CASE #PL2020-112

MINNESOTA
CAMPUS PARKING
RAMP

Item	Date
CITY SUBMITTAL	07-08-202

CIVIL DETAILS

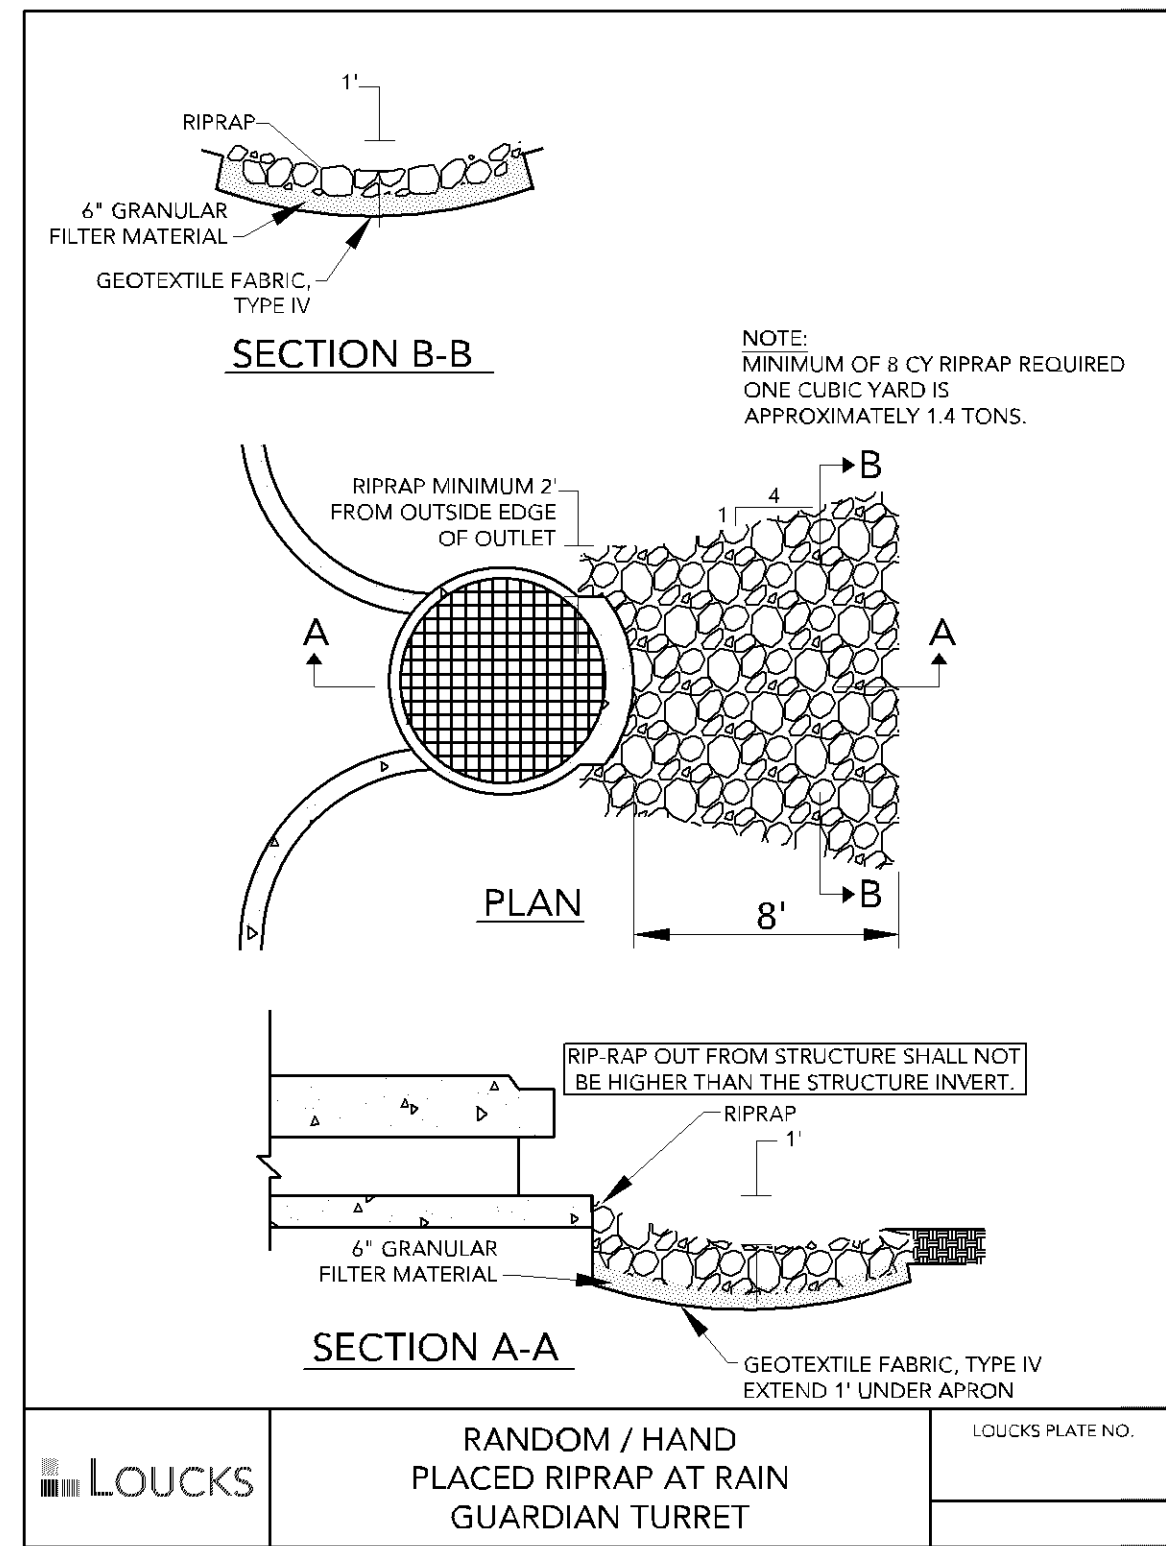
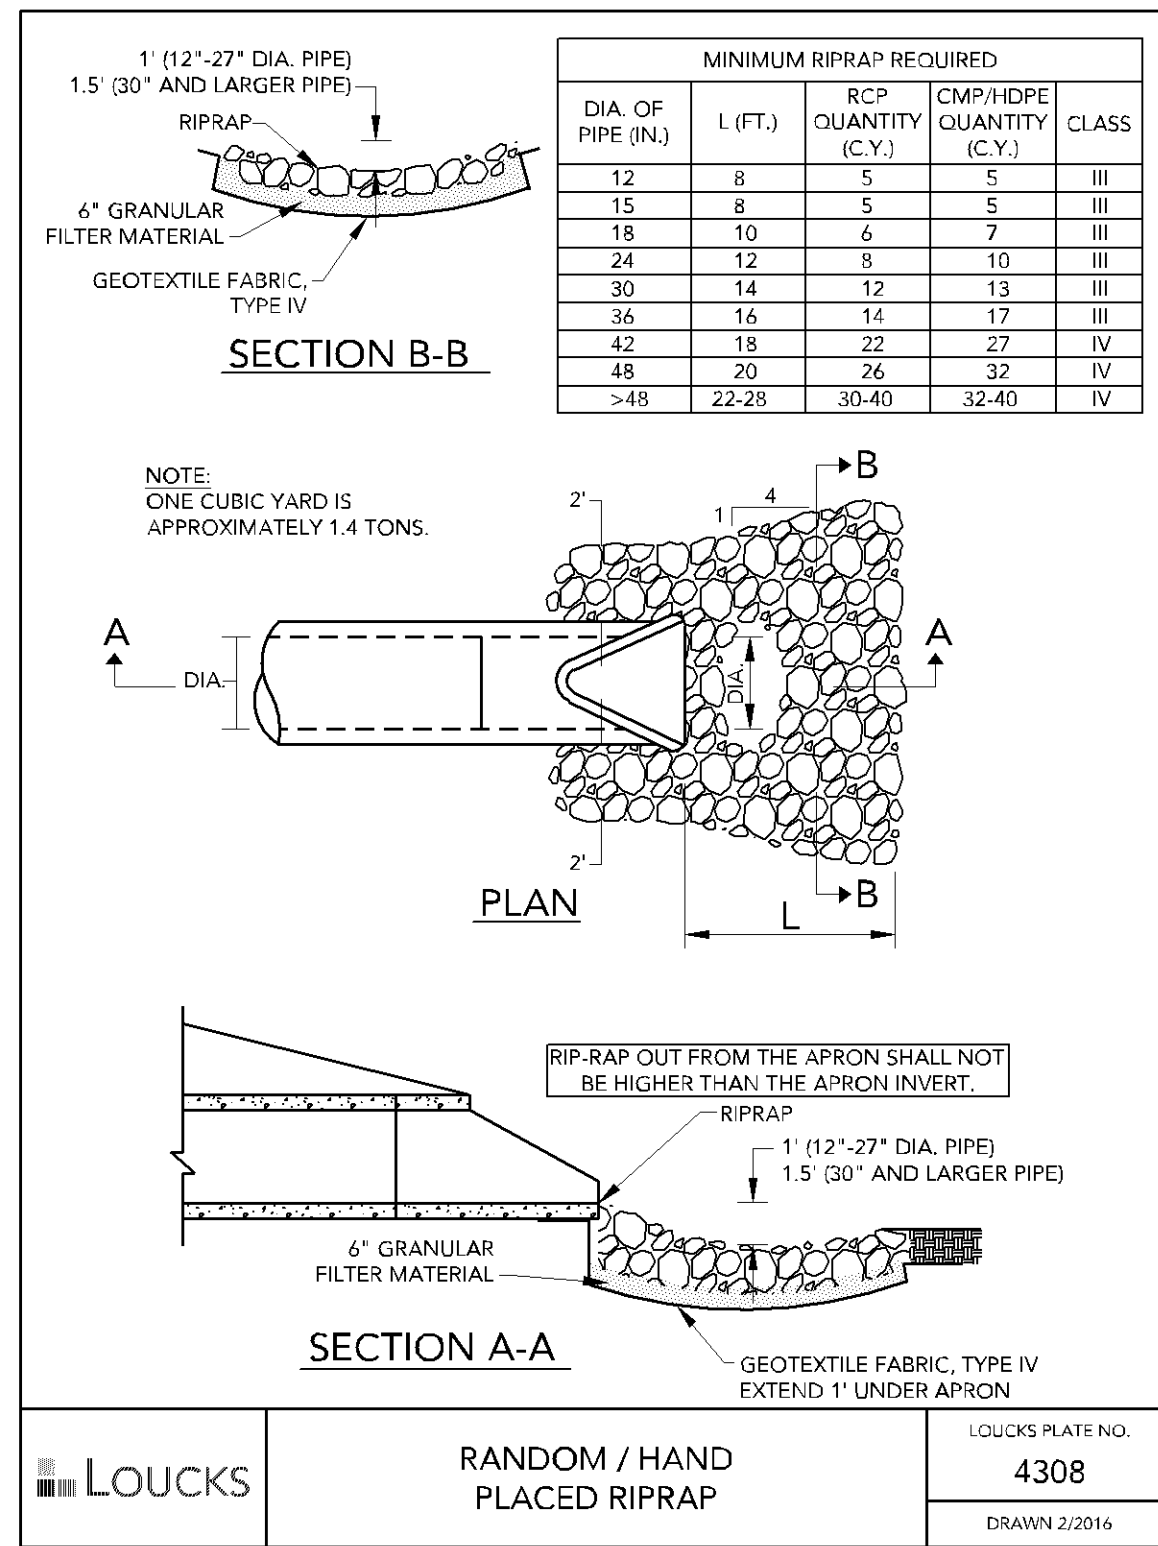
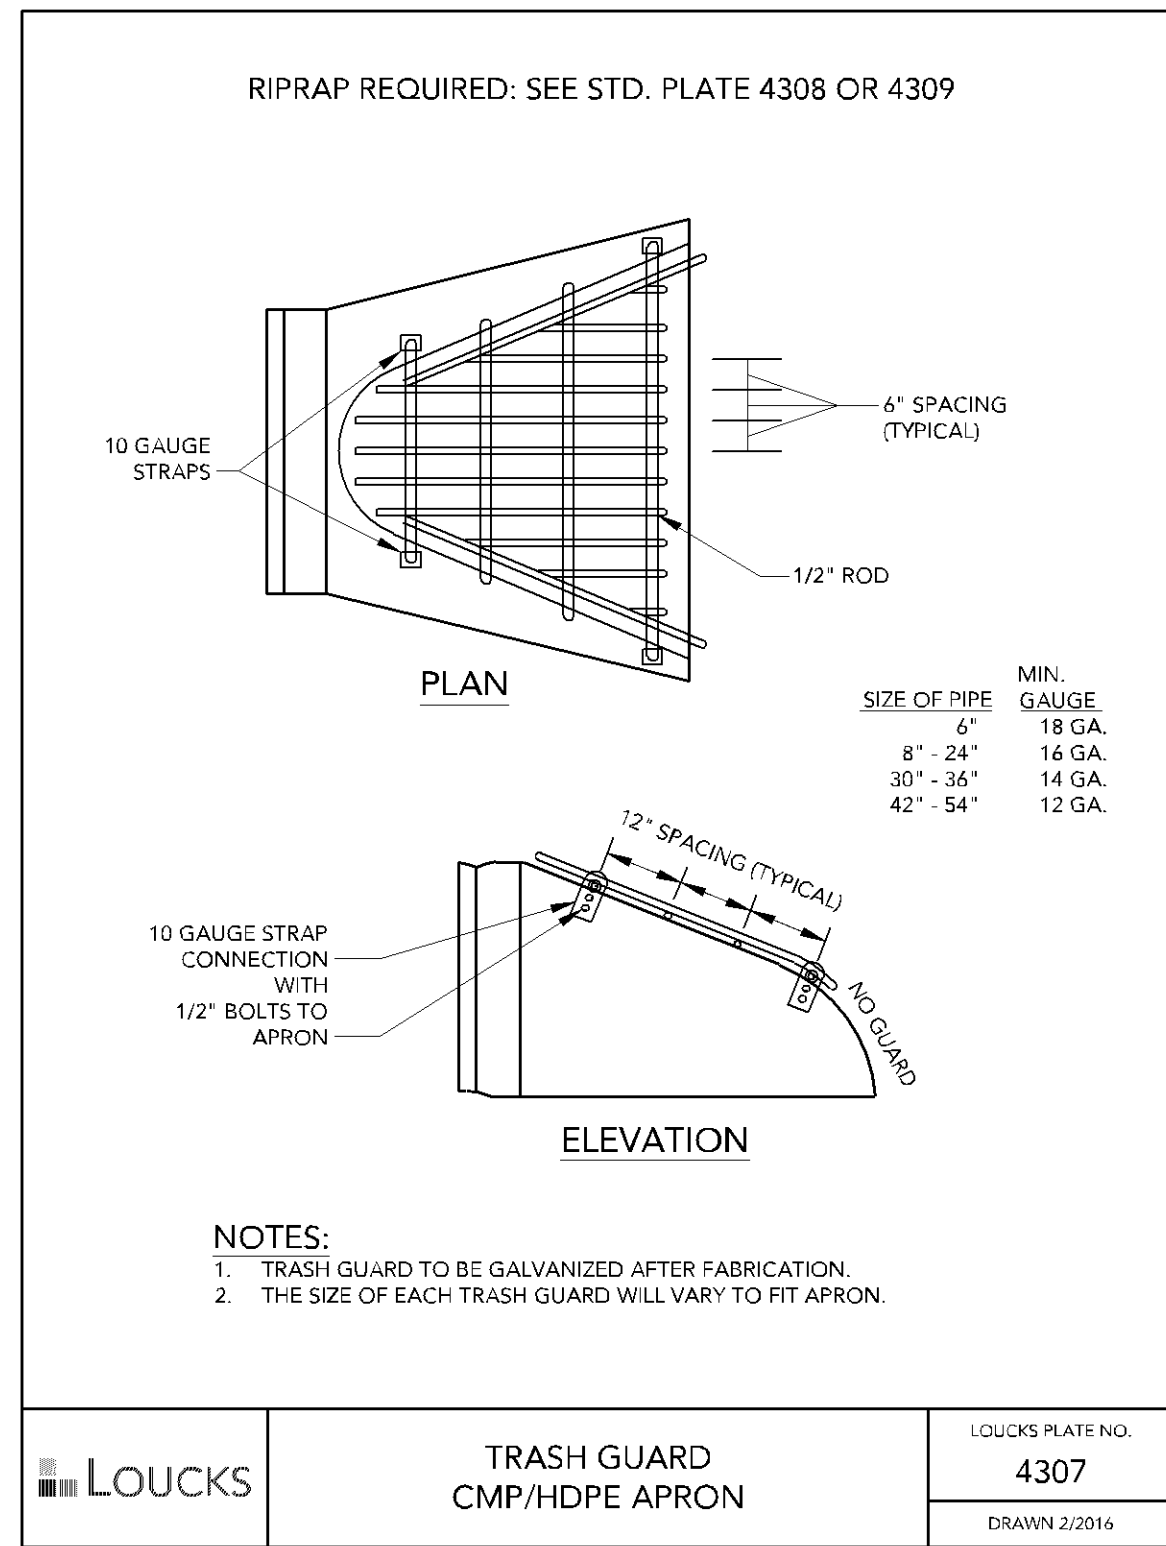
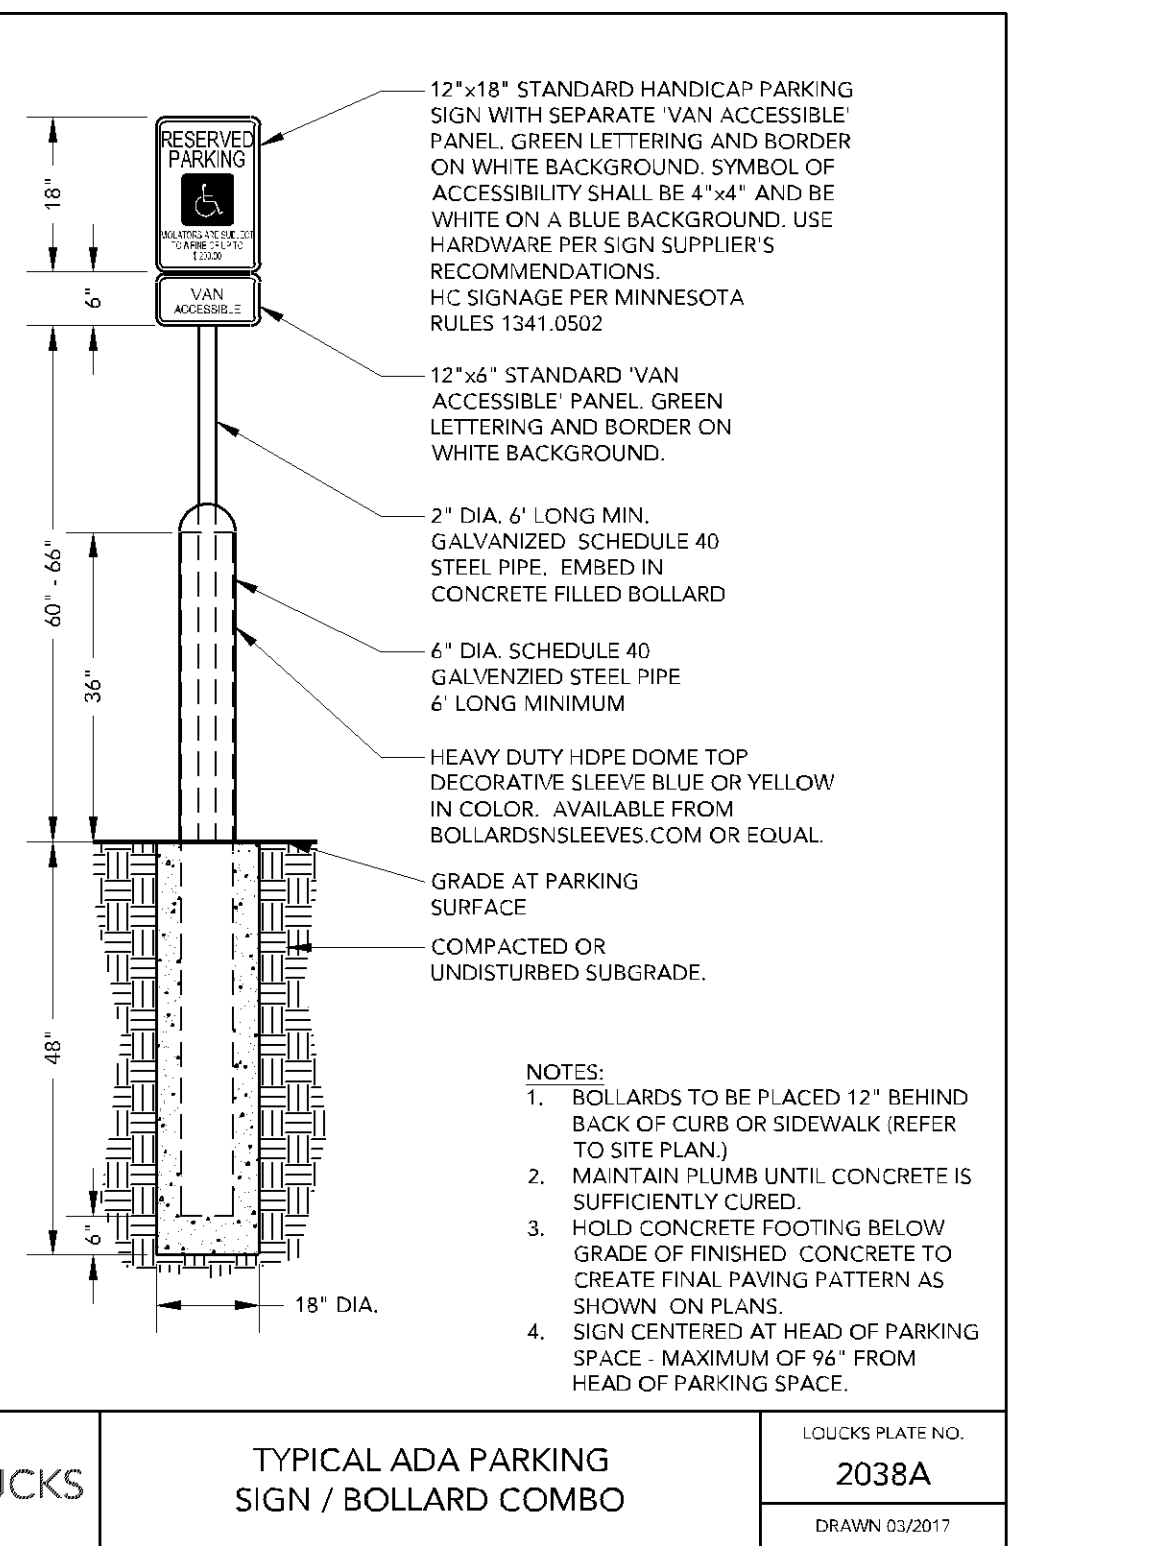
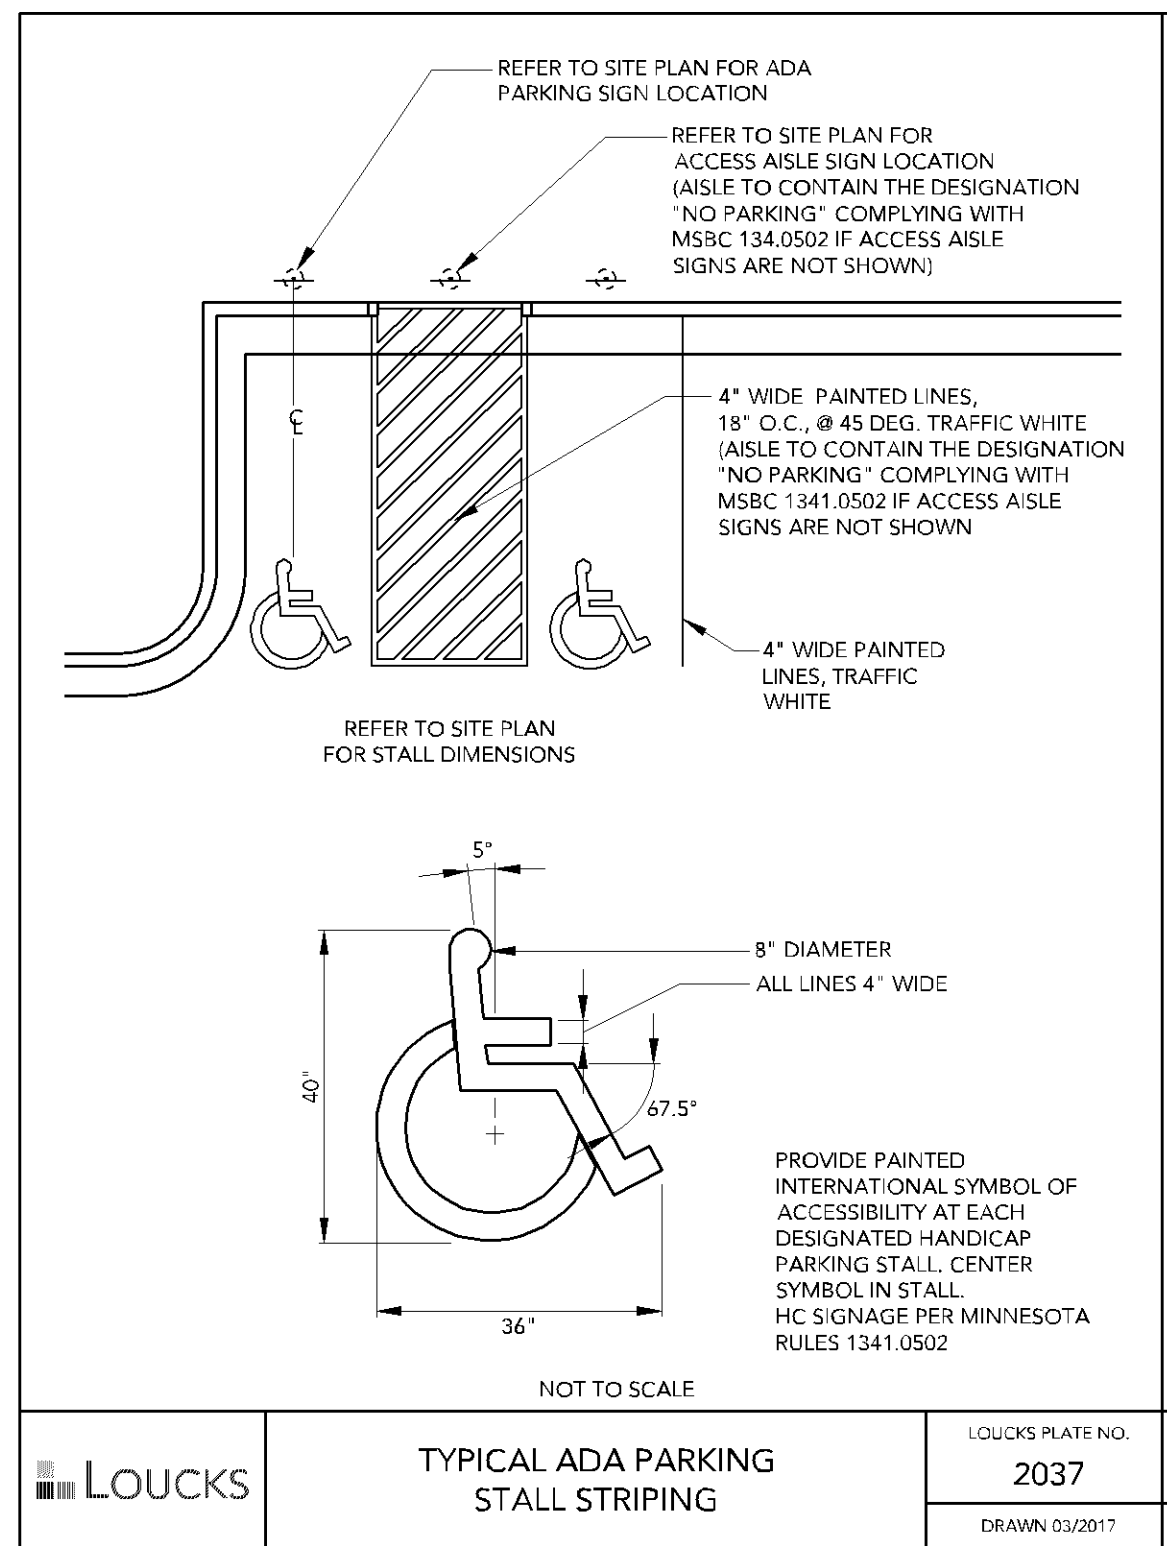
Provide thrust block detail, see City website
